# Access Compliance Report

Intersection ID: 48058	Main Street: FERRELL_AV	Cross Street: KEENER_RIDGE_RD	Location: NE
ADA ID: 1A15DB903136	Ramp Type: Perp	Initial Pass/Fail: Fail	Overall Compliance: No
		Severity Score: 8.75

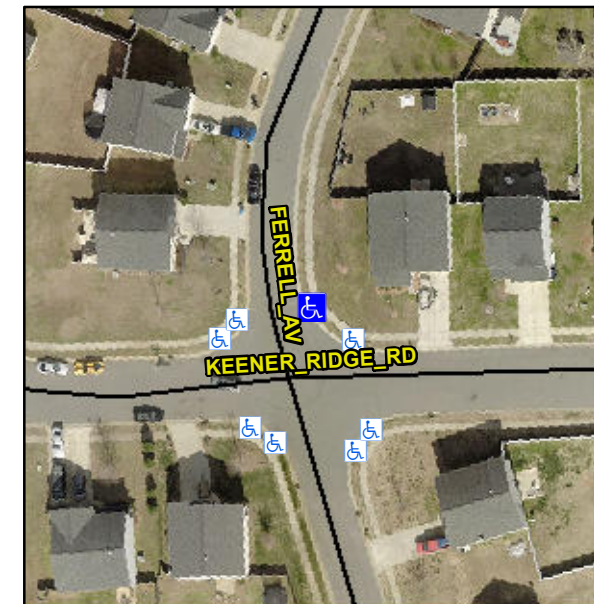
**Not Found, R304.5.1**

Compliance	Description	Data	Compliance	Description	Data
N/A	Ramp Length (in)	47.5	Yes	Ramp Slope (%)	5.9
No	Ramp Width (in)	47.0	Yes	Ramp XSlope (%)	1.4
N/A	Flare Type LT	N/A	N/A	Flare Type RT	N/A
N/A	Flare Slope LT (%)	N/A	N/A	Flare Slope RT (%)	N/A
N/A	Flare Traversable LT?	N/A	N/A	Flare Traversable RT?	N/A
N/A	Landing Length (in)	N/A	N/A	DWS Provided?	N/A
N/A	Landing Width (in)	N/A	N/A	DWS Contrast?	N/A
N/A	Landing Slope (%)	N/A	N/A	DWS Length (in)	N/A
N/A	Landing X Slope (%)	N/A	N/A	DWS Full Width?	N/A
N/A	Landing Curb? (Y/N)	N/A	N/A	DWS Offset (in)	N/A
N/A	Shared Landing?	N/A			
N/A	Gutter Ponding?	N/A	N/A	Gutter Slope (%)	N/A
N/A	Gutter Lip Ht (in)	N/A	N/A	Gutter X Slope (%)	N/A
N/A	Painted X Walk1?	No	N/A	Painted X Walk2?	N/A
	X Walk 1 Direction	To W		X Walk 2 Direction	N/A
N/A	X Walk 1 Width (in)	N/A	N/A	X Walk 2 Width (in)	N/A
	X Walk 1 Slope (%)	6.6		X Walk 2 Slope (%)	N/A
	X Walk 1 X Slope (%)	0.4		X Walk 2 X Slope (%)	N/A

**Remove & Replace Entire Ramp.**
